SUBJECT: Twin Pines Minerals, LLC Permit Coordination Comments
Mine Name: Saunders Demonstration Mine
County: Charlton

Twin Pines Permit Coordination Document
Charlton County: Saunders Demonstration Mine
April 14, 2021

1. **Surface Mining Application and Mining Land Use Plan Review Comments by Surface Mining Unit (Contains most MLUP sheets)**
 - a. Please add Mine ID No. 2073 to each sheet or Figure.

4. **Provisions Check List and Explanations for Protection of the Environment and Resources of the State Comments by: Surface Mining Unit**

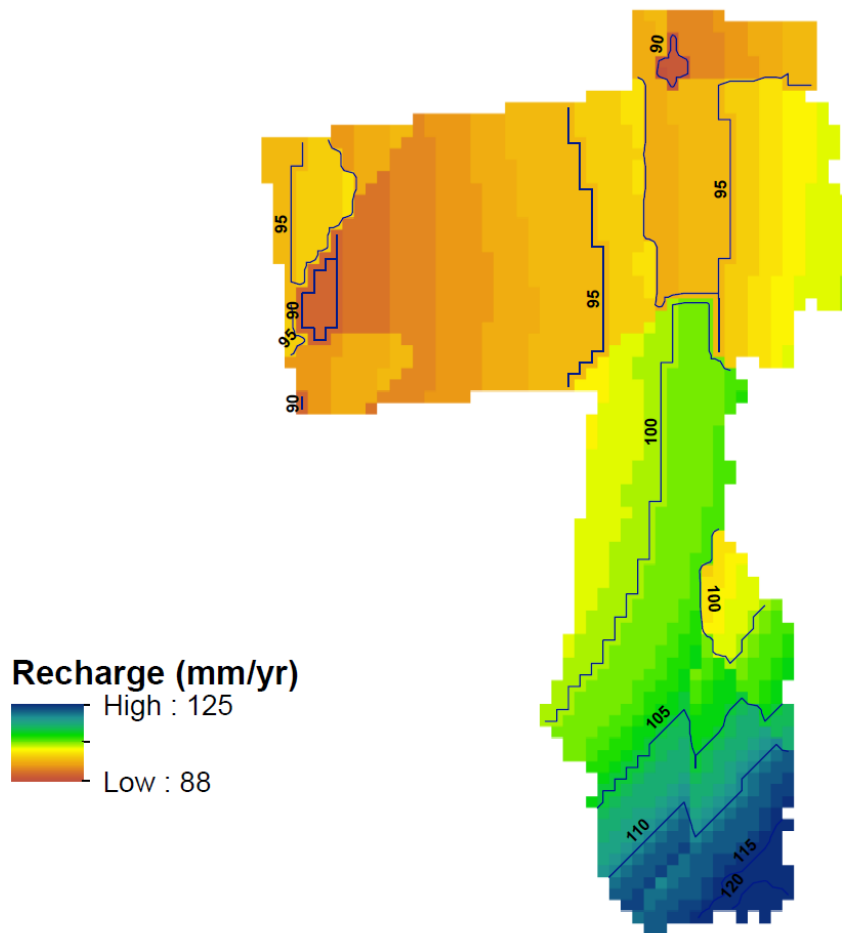
- a. Explanations
 - i. Please note that the Surface Mining Rules Section 391-3-3-.05(1) requests that the Mining Land Use Plan include provisions for protection of the environment and resources of the State. The checklist that was provided to Twin Pines, was taken from GEPA but meant to be used as a guidance for Twin Pines to follow and make their own. EPD is not asking Twin Pines to follow GEPA regulations. The provisions checklist will be an addendum to the Surface Mining Land Use Plan (MLUP) and used during public meetings as an outline of the affects the Twin Pines project may have on the surrounding environment and resources of the State.

- ii. Wetlands- Give a brief description of how the non-jurisdictional wetlands will be temporarily affected and then reclaimed.
 - iii. Flood Plain/River Corridor- Cite the source that was used to determine the claim.

- iv. Water Supply- State how the proposed withdrawal is compared to the production capacity of the Floridan Aquifer. Also provide the distance to the nearest known supply well, public or private, completed in the Floridan Aquifer. Will withdrawal from the Floridan Aquifer create a cone of depression that may impact nearby watersheds? If so, this data needs to be provided or pointed to within the MLUP.

- v. Water Resources- Please provide an explanation of any potential water quality impacts as a result of the groundwater withdrawal from the Upper Floridan Aquifer.

- vi. Groundwater Recharge- No comment.
 - vii. Stormwater- Please state the name of the receiving stream from the discharge. Provide details of a contingency plan if discharge is greater than pre-mining conditions. Briefly describe erosion/sediment controls at discharge location(s).

- viii. Wastewater- Briefly state how the water will be treated and how the effluent will be monitored for permit compliance.
 - ix. Air Quality- Briefly describe how Twin Pines will minimize particulate/opacity emissions. This area is for the mine boundary as well as the plant.

- x. Solid Wastes- The first sentence indicates that process solid waste may be generated but will stay on-site; please clarify what Twin Pines will do with processed solid waste. Second sentence- Please state how the office-related waste will be properly transported and disposed. Can you describe how the land clearing will be handled?

- xi. Soil/Stability/Erodibility- Please describe how the site will reduce the potential for sediment-laden soils to leave the site. Briefly describe the berm during mining activities and the deposition of the berm following reclamation.
